Subject: 113 North Avenue West
Block 183, Lot 6
ZBA-22-009
C(2) Variance and D(3)-Conditional Use & D(5)- Density Variance Application

Planning Report #2

DATE: November 13, 2023
TO: Zoning Board, Township of Cranford
FROM: Greer Patras, AICP, PP, Board Planner
APPLICANT: Carwen Management LLC
ATTORNEY: Gary S. Goodman, Esq.
SUBJECT: **APPLICATION (#22-009)
113 NORTH AVENUE WEST
BLOCK 183, LOT 6
PRELIMINARY AND FINAL MAJOR SITE PLAN
WITH USE VARIANCES AND BULK VARIANCES**

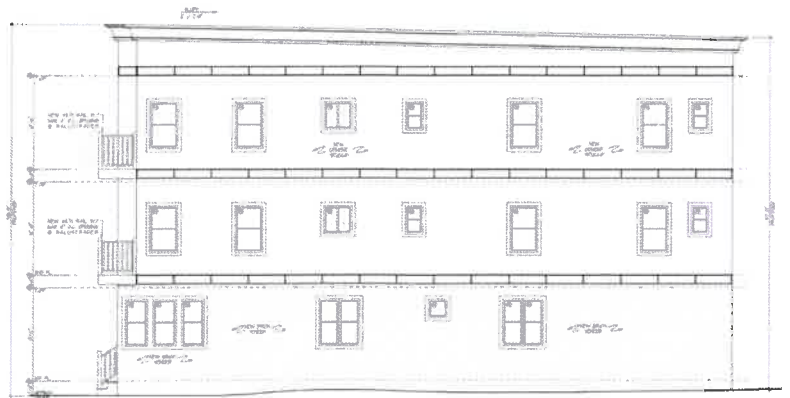
1. The Applicant should provide an overview of the proposed building design, massing, colors, and materials. Given the intensity and importance of the variances requested, renderings should be presented to show each facade colors and materials. *Colors have still not been provided on the plans.*

Testimony was provided at the first hearing; however, the Applicant should provide an overview of the revised building design and how it addresses the comments from the Board and DMC.

The brick occupying the whole first floor, then having different material bands at each level, and stucco at the top is a building style unfamiliar to us. The Applicant should present other building forms in history or in the area that have this type of material combination and form, to help demonstrate compliance with the intent of the Ordinance and goals of the Master Plan. Colored renderings should be provided.
